INDEPENDENT ADVISORY
PANEL FOR UNDERGROUND
MINING

ADVICE RE:

**NARRABRI UNDERGROUND
MINE**

STAGE 3 EXTENSION PROJECT

Figure 1. Conceptual Geological Profile West-East through the mine licence area (reproduced from Figure 5.18 of the EIS, Appendix B - Groundwater Assessment)

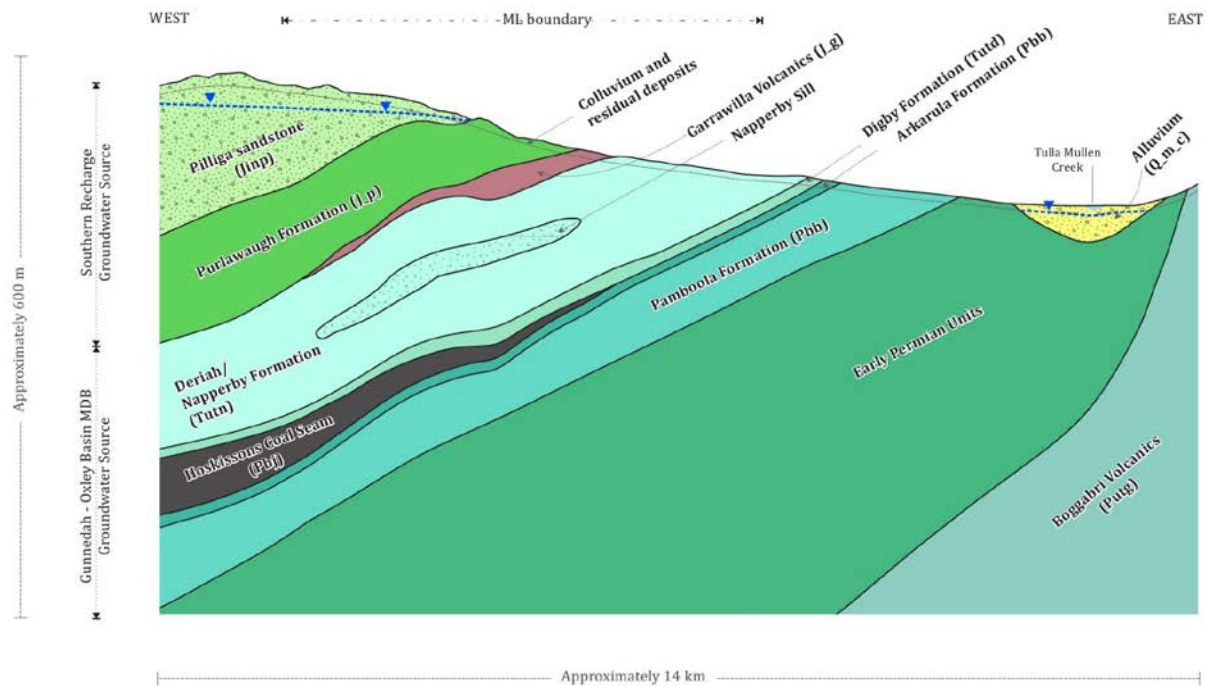
The hydraulic properties of the formations are determined from the available data with large initial estimates and ranges for hydraulic conductivity anisotropy (K_h/K_v) for the Purlawaugh and Napperby formations of 1,000 and 100 to 10,000, respectively.

Key model features are the distinctively different groundwater environments encapsulated within the modelled region and the significant hydraulic conductivity anisotropy adopted for the major formations around the mined area. There is a major change in hydrogeological functioning between the Namoi alluvium to the east of the modelled area and the Pilliga aquifer area to the west in terms of both hydraulic properties and consumptive uses. Importantly the mine area is connected to the alluvium by low hydraulic conductivity units (<0.01 m/d) implying low risk of strong connections between the alluvium and the mine. Equally important, the mine area is connected to the surface and to the Pilliga Sandstone aquifer by units with very low vertical hydraulic conductivity. The reliability of the low vertical conductivity values is uncertain, particularly for the post-mining conditions. The mine is surrounded laterally and vertically by low conductivity formations. This suggests that post mining the long-term recovery of the groundwater system can be anticipated to return to close to pre-mining conditions with long times for return flows to the surface from the mined horizon.
